# Effective Return Loss (ERL) To Limit COM Variability

For Comment Resolution of r02-26, r02-55, and r02-56

IEEE P802.3bs Task Force

July 2017

# Return Loss for “Cap Variation 1” Passes

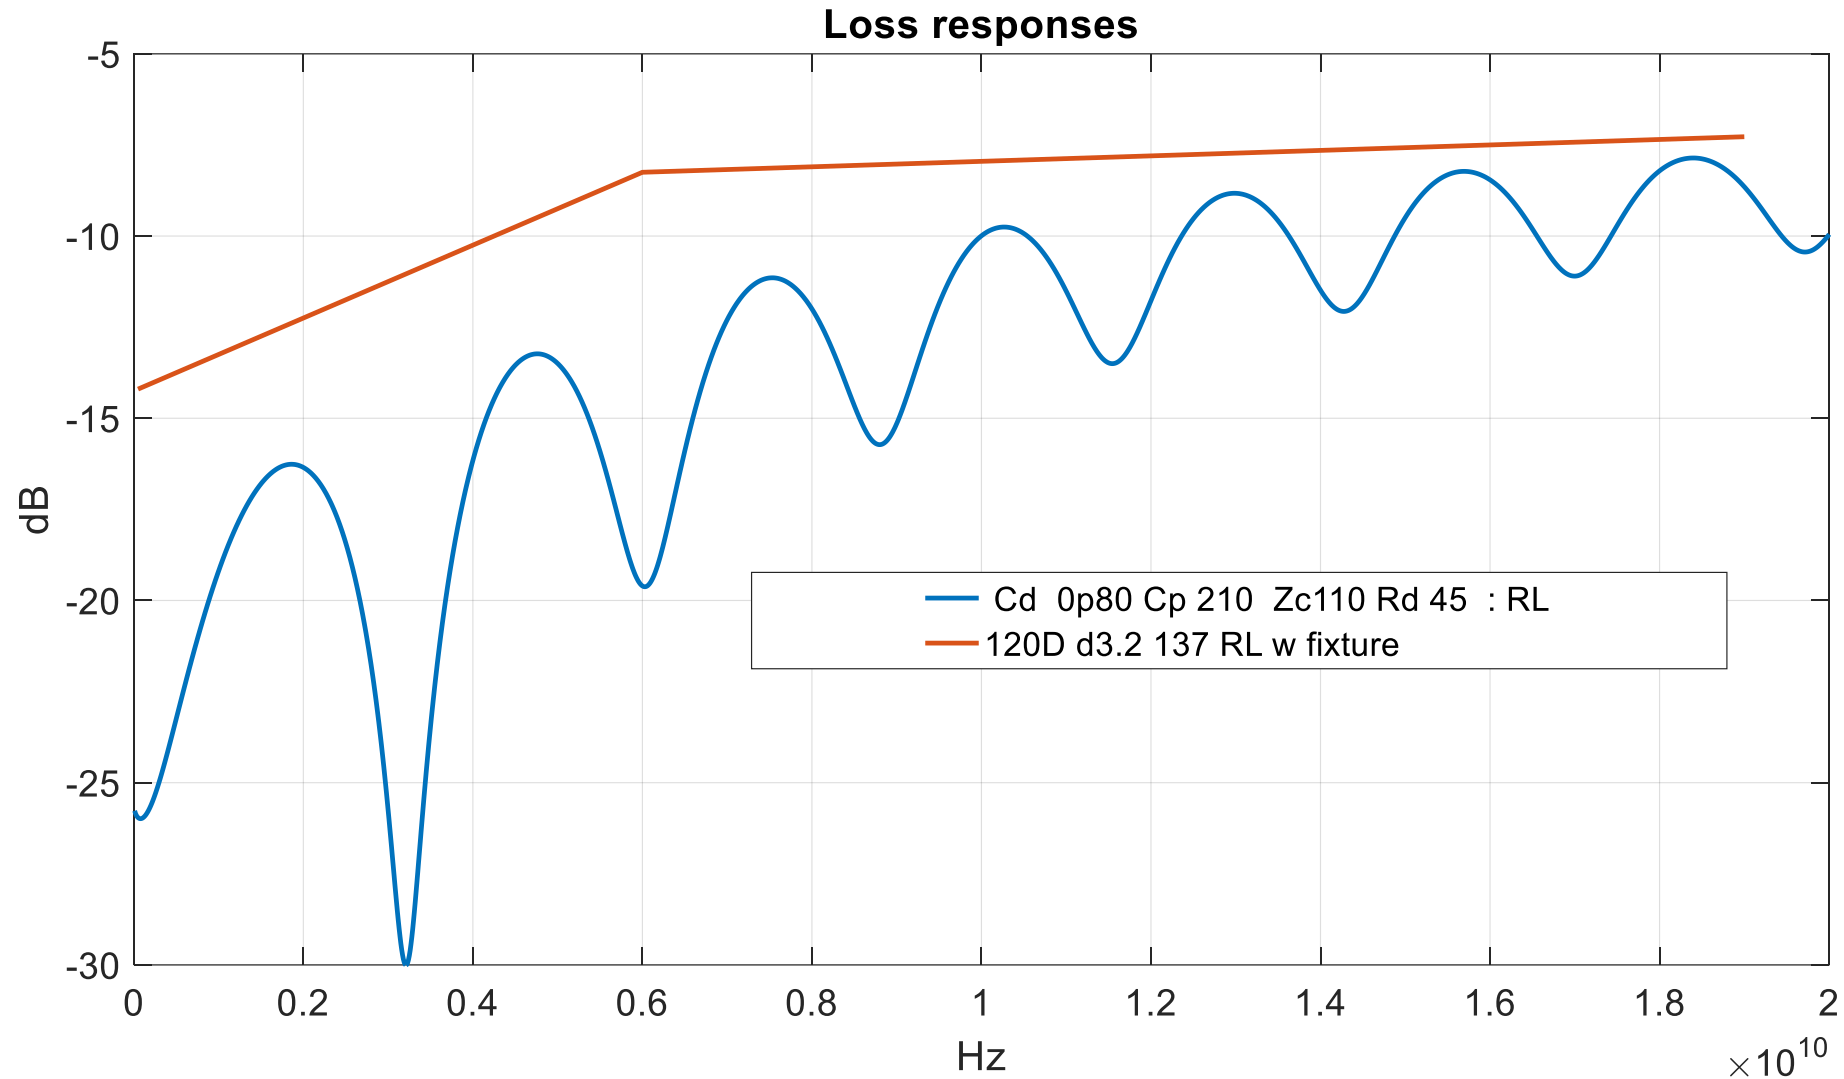
“Cap Variation 1”

- Has less device capacitance
- But more package capacitance

# Proposal: Add a New Requirement for Effective Return Loss (ERL)

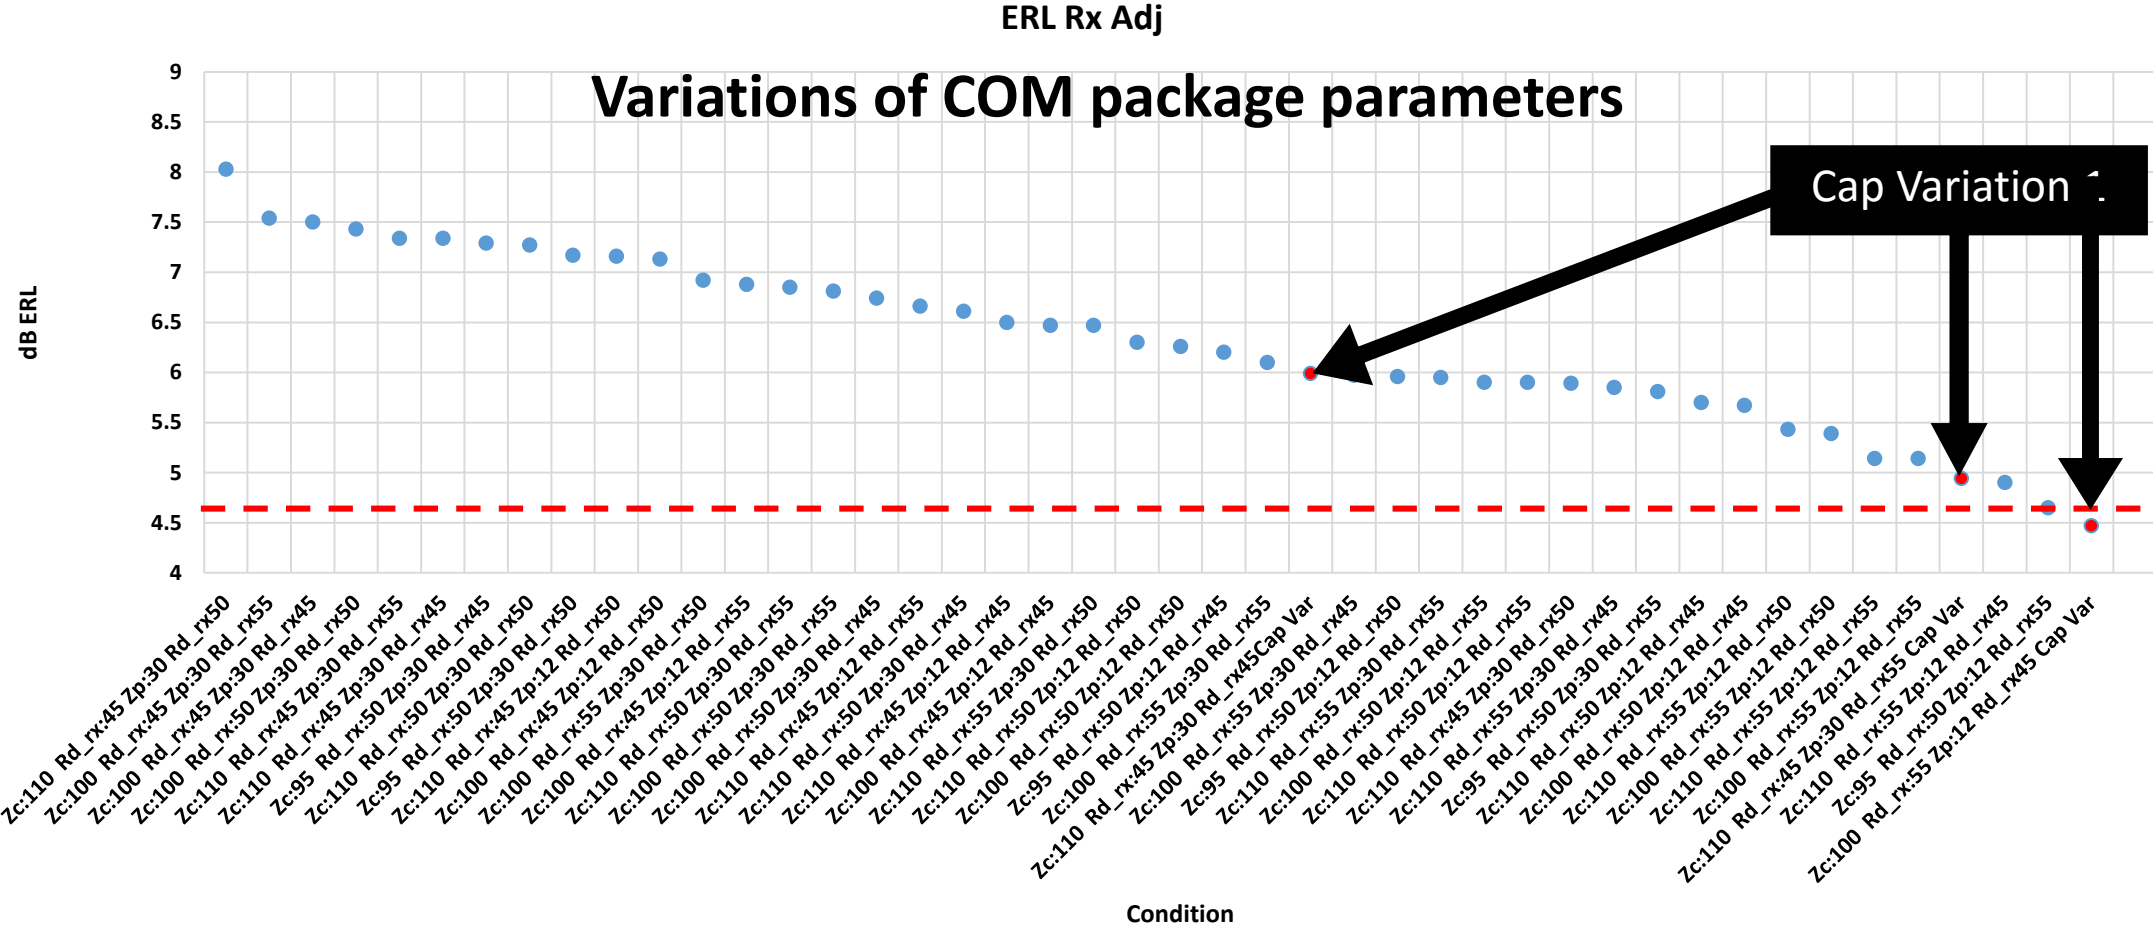
ERL is in the context of signaling

ERL uses a time domain “echo” from single pulse (symbol)

ERL is computed from the pulse echo response (PER) using methods similar to COM

Compensate ERL for transmitter using  $V_p/V_f$  ratio

# Add ERL Row to Table 120D-5

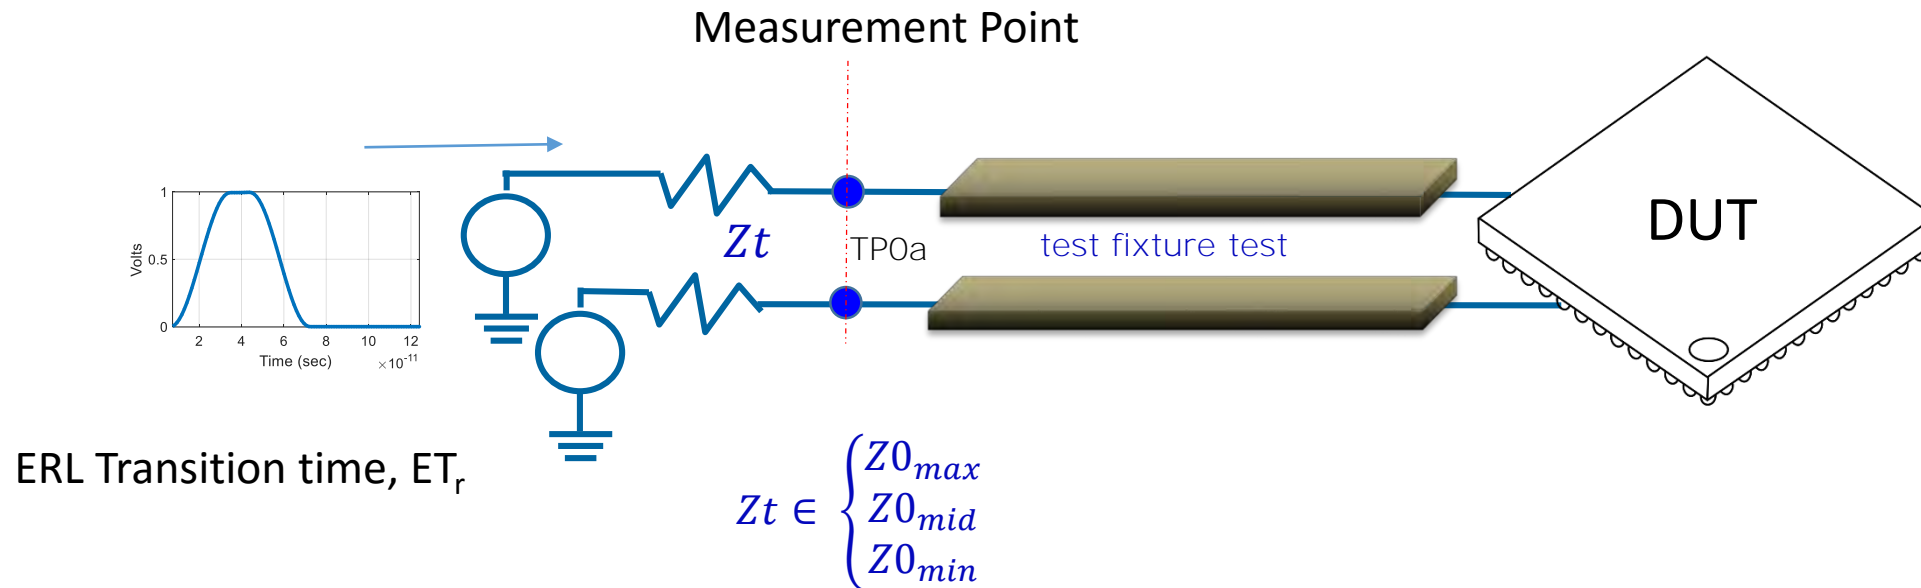
## □ Add note for the ERL row

- use a 18 ps (20%-80%) transition time and
- Use a 4<sup>th</sup> order Bessel-Thomsen Filter with dB point at  $0.75 f_b$

- $Z_t \in \begin{cases} 55 \\ 50 \\ 45 \end{cases}$

## □ ERL max > 4.6 dB

# Determine PTDR response for each $Z_t$

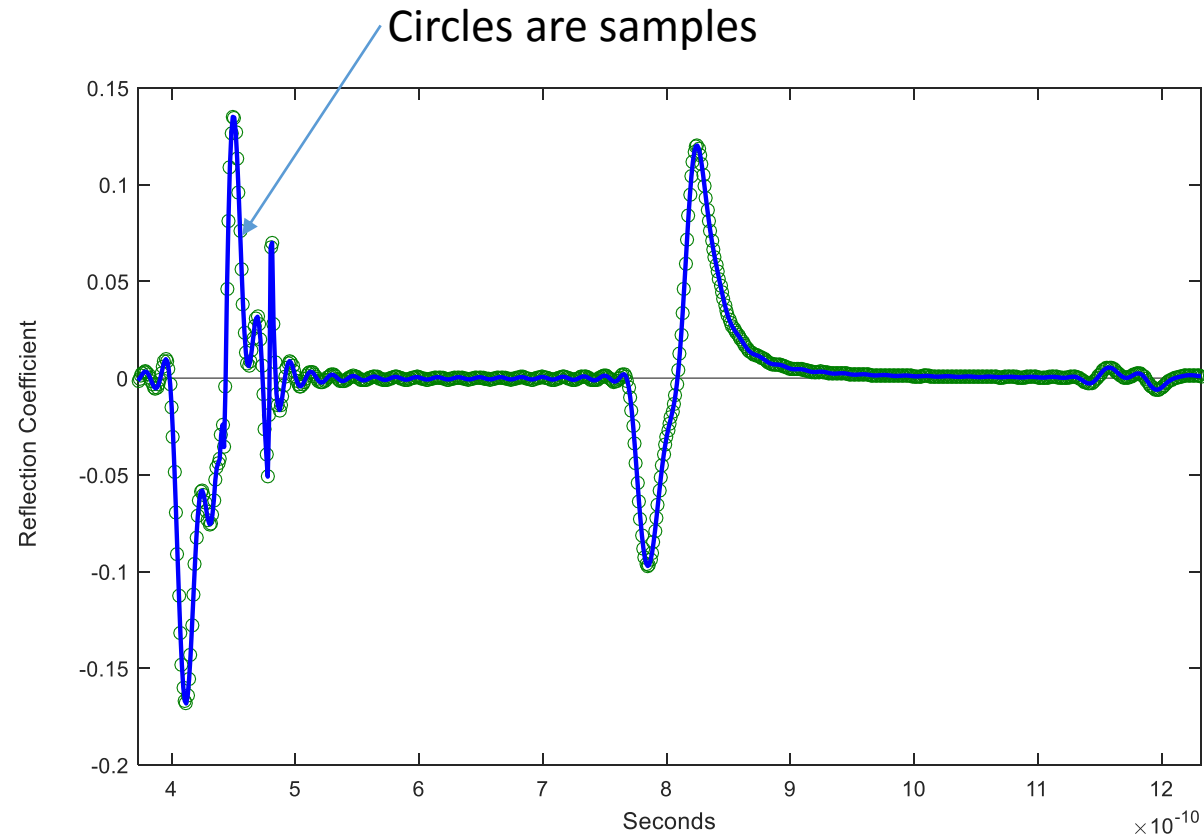
PTDR measurements are in terms of rho ( $\rho$ )  
PTDR may be computed from s-parameter responses

# Determine effective reflection coefficient for each sample in a unit interval

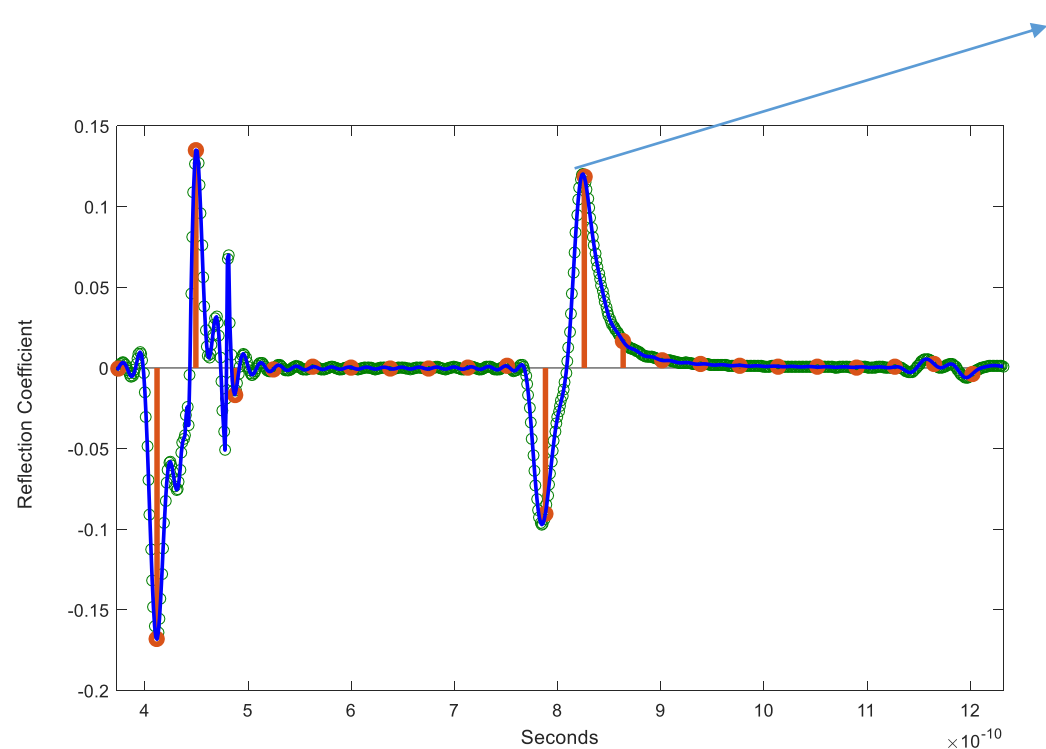
$S(n,m)$  where  $m = 1$  to numbers samples per UI,  $M$   
and  $n = 1$  to number of UI's in response,  $N$

Note:  $M \times N$  is the number samples response
